Comments on the Adequacy of the Sydney Tar Ponds Agency SS Remediation Objectives

June 14, 2010

Figure 1

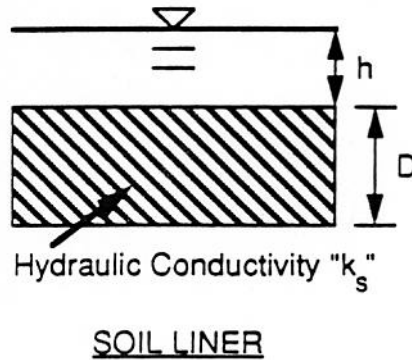
As shown in Figure 1 from a US EPA landfill cover design manual, the actual rate of movement of water and some pollutants through the SS-treated sludge having a particular permeability, depends on the amount of water ("head") above the SS treated sludge; the greater the head, the more rapid the transport through the medium. If the SS treated sludge cover permeability is like the SS treated sludge itself, then at times, there will be water passing through the cover into the SS treated sludge. As shown in Figure 2, a soil layer as a cover with a permeability of 10^{-6} cm/sec will allow 1,200 gal of water to pass through it every day with one foot of water (head) on the cover. Even with a thin layer of water on top of the treated sludge, such as would occur after rainfall or snow melt, the water will pass through the cover and through the SS treated sludge carrying with it leachable pollutants.

The bottom line is that a 10^{-6} cm/sec permeability in the SS treated sludge will allow leachable pollutants to move through the SS treated sludge at a relatively high rate and not be protective of the Sydney Harbour from further pollution by hazardous chemicals in the sludge. Information on the rapid breakthrough times of layers of materials. Figure 3 presents a graph from Workman and Keeble that shows these relationships. This issue is discussed in the following paper:

Figure 3

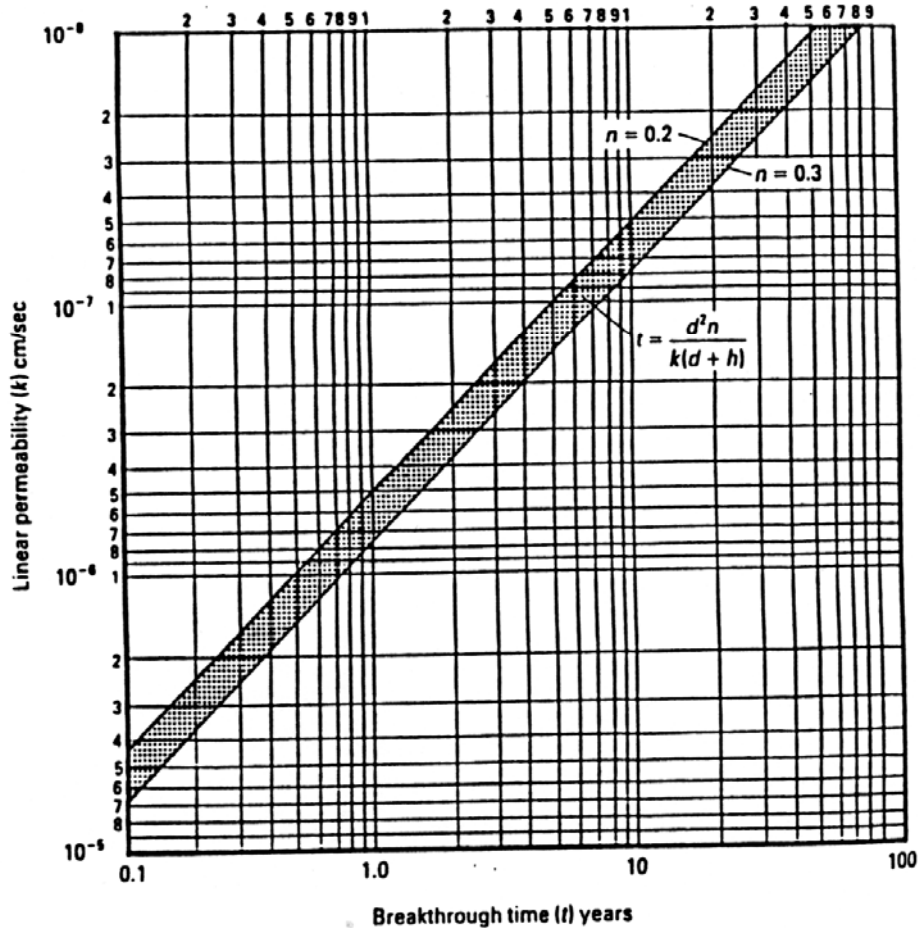
As shown a 1 meter thick layer of compacted soil or other media with a permeability of 10^{-6} will have a break through time (be penetrated) in a few months.
